BRT/BARNBECK
FRAME

VERMONT
FRAMES

SECOND FLOOR FRAMING PLAN
@ 15'-0" AFF ELEVATION

BRT/BARNBECK
FRAME

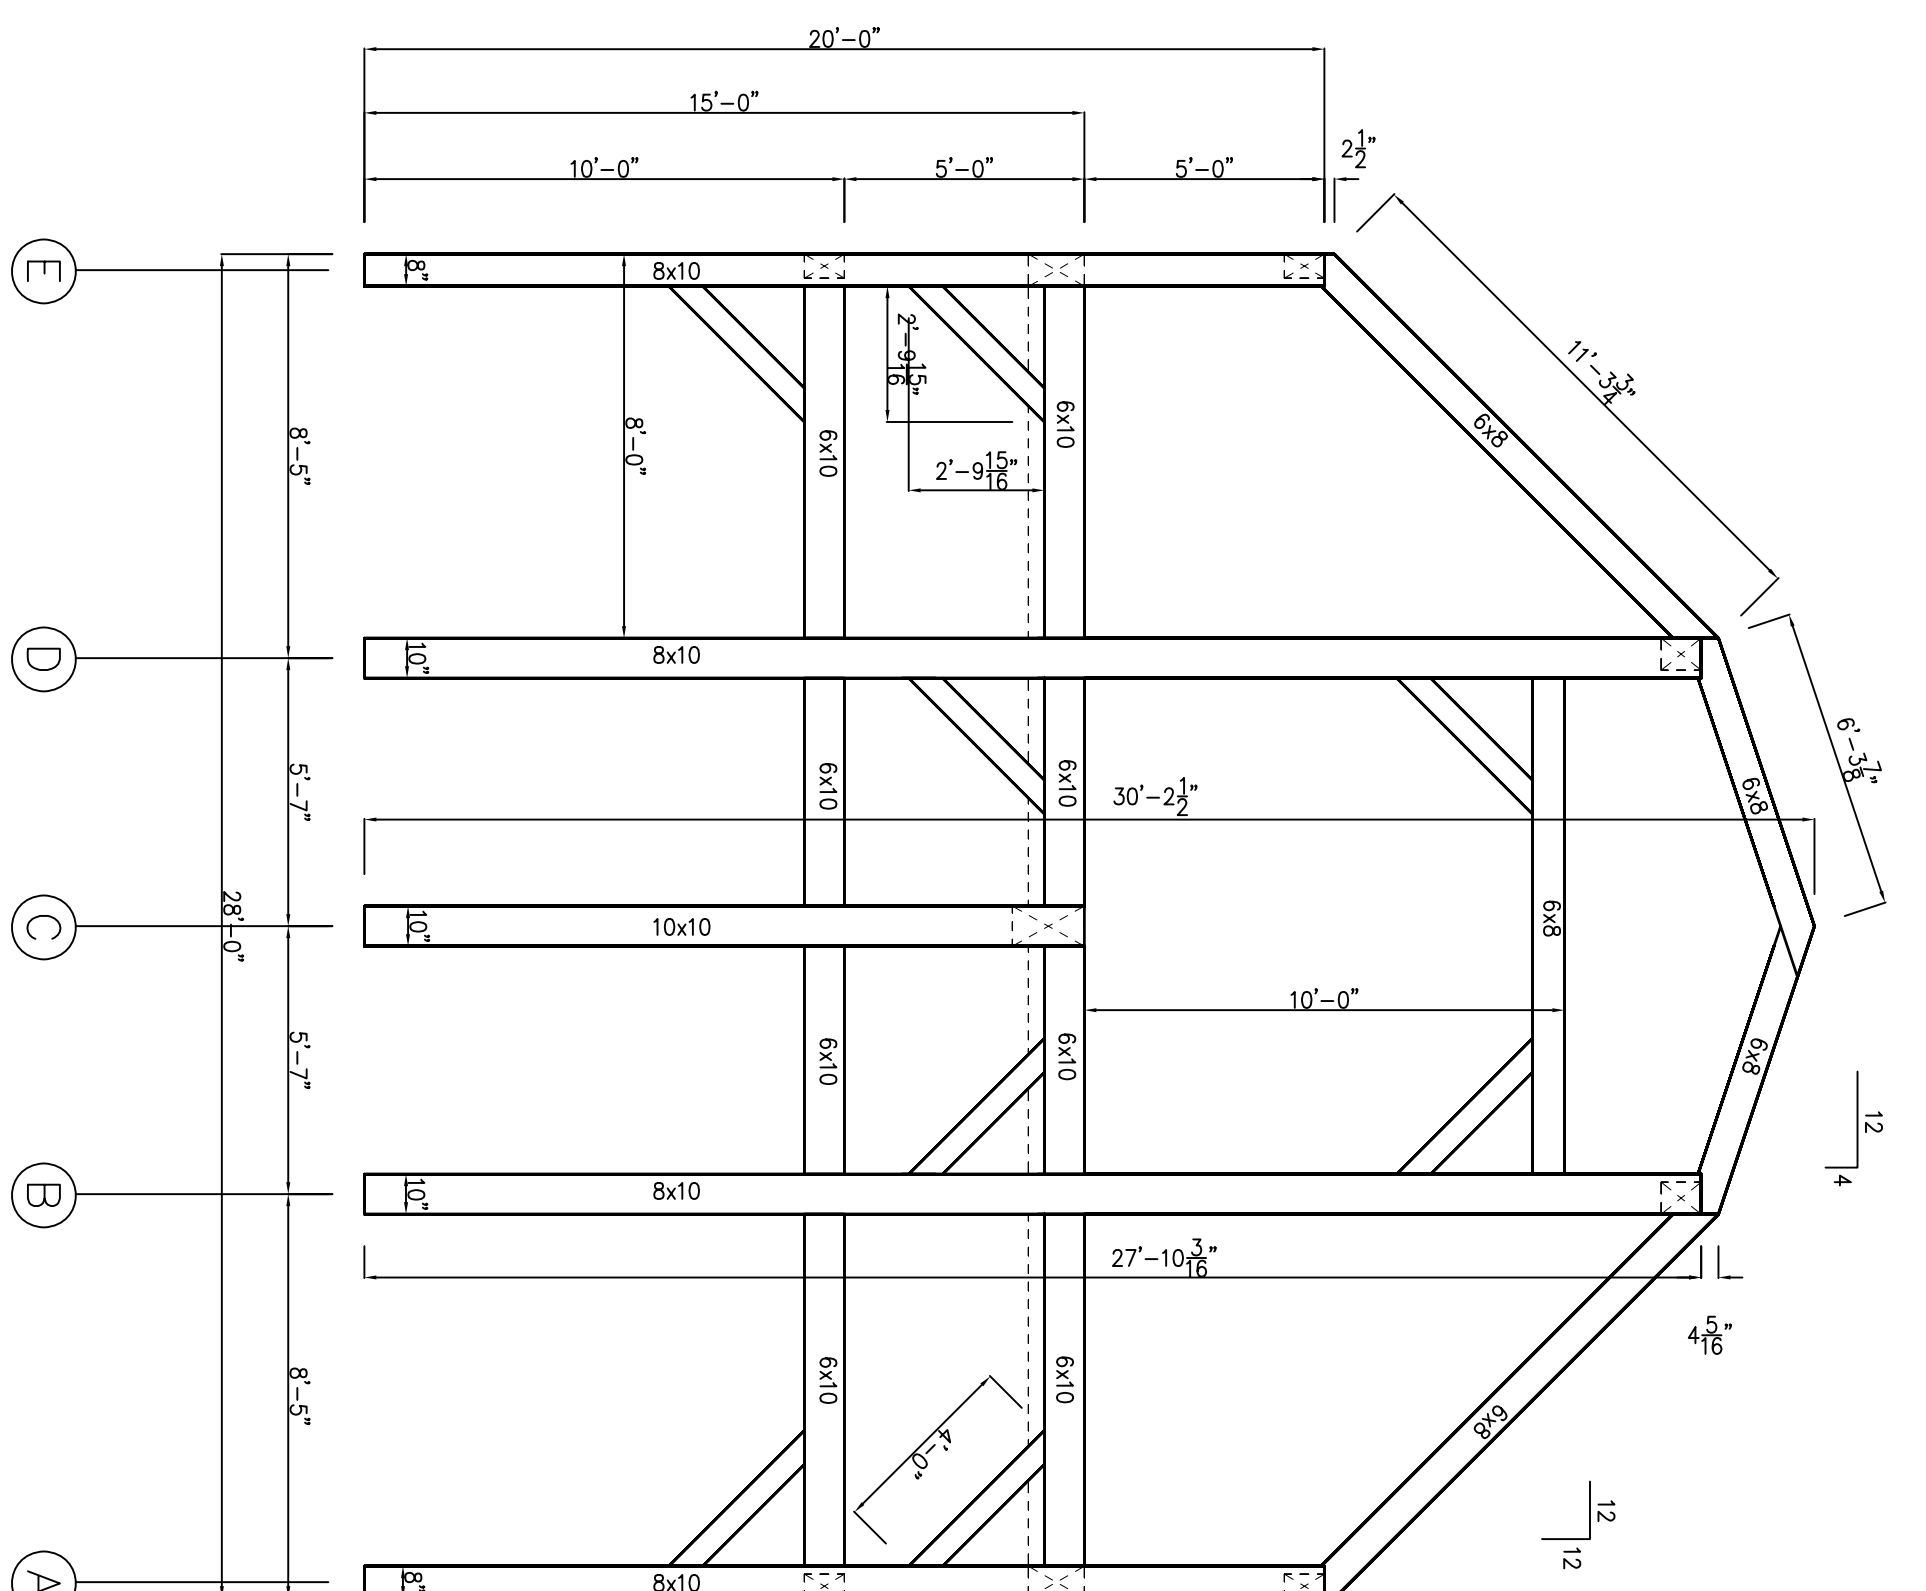
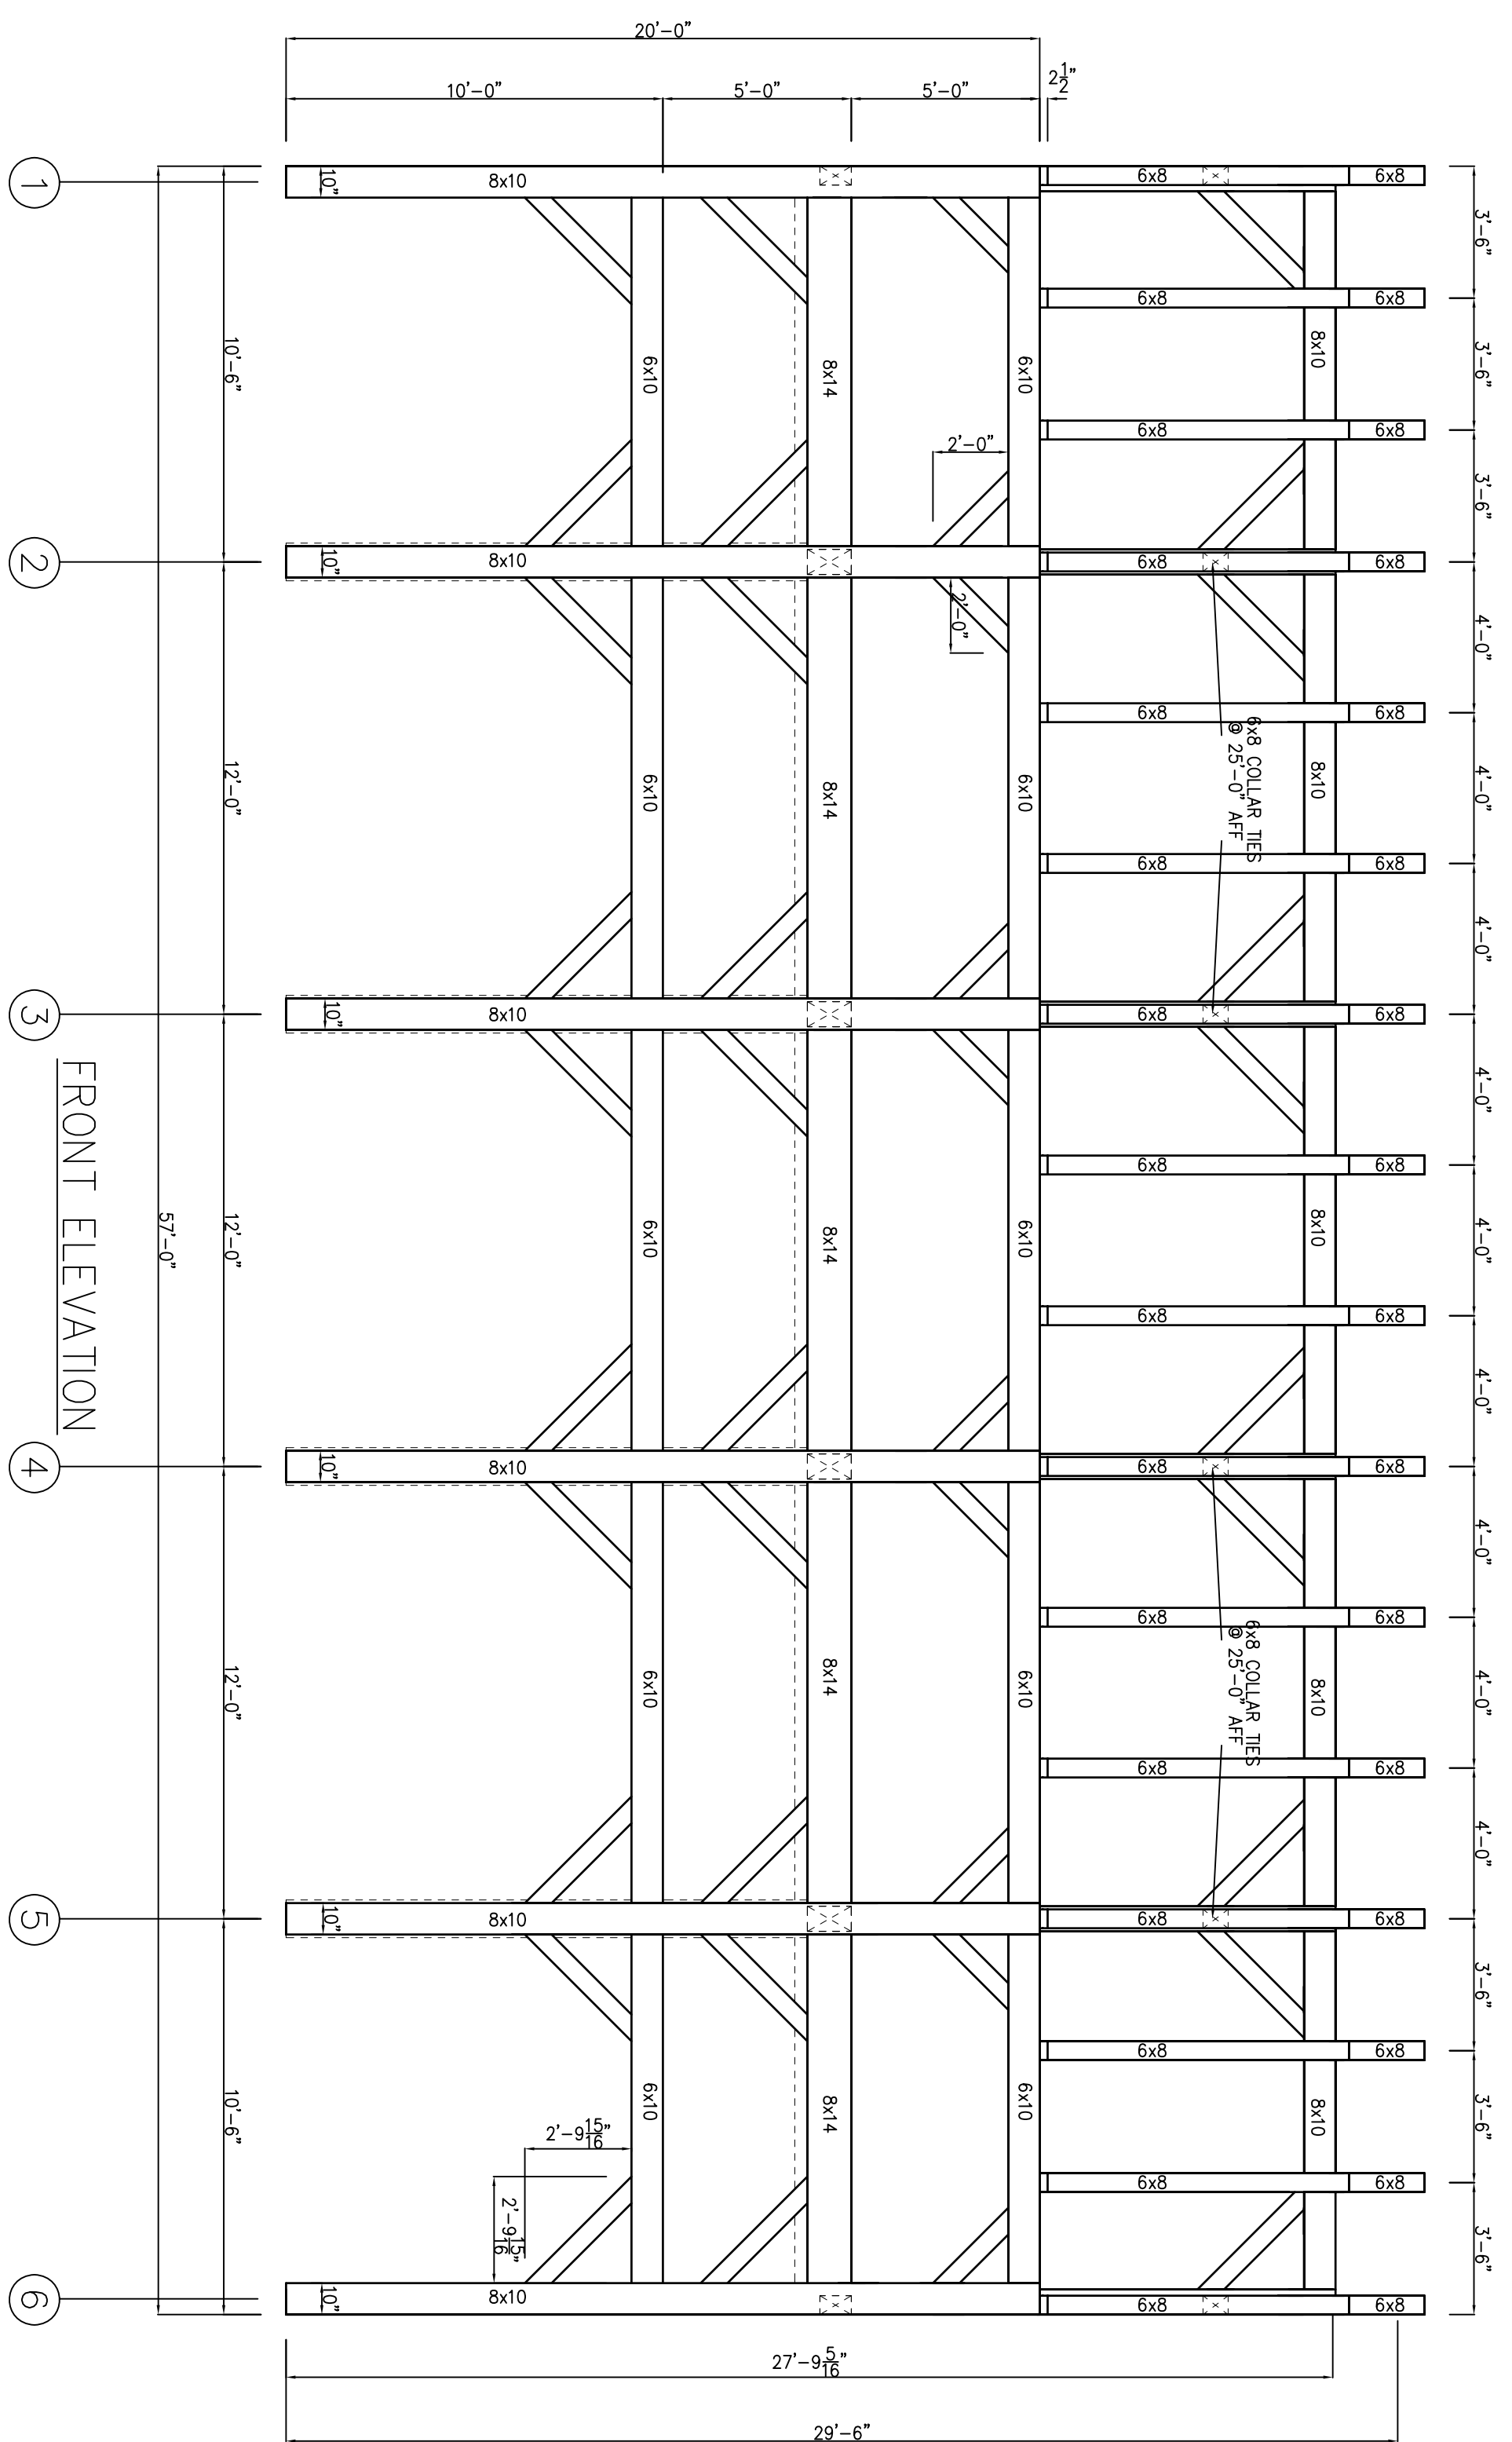
PLANS WILL NEED TO BE RE-SUBMITTED TO ENGINEER, DUE TO CHANGES IN INTERIOR POST LOCATIONS.
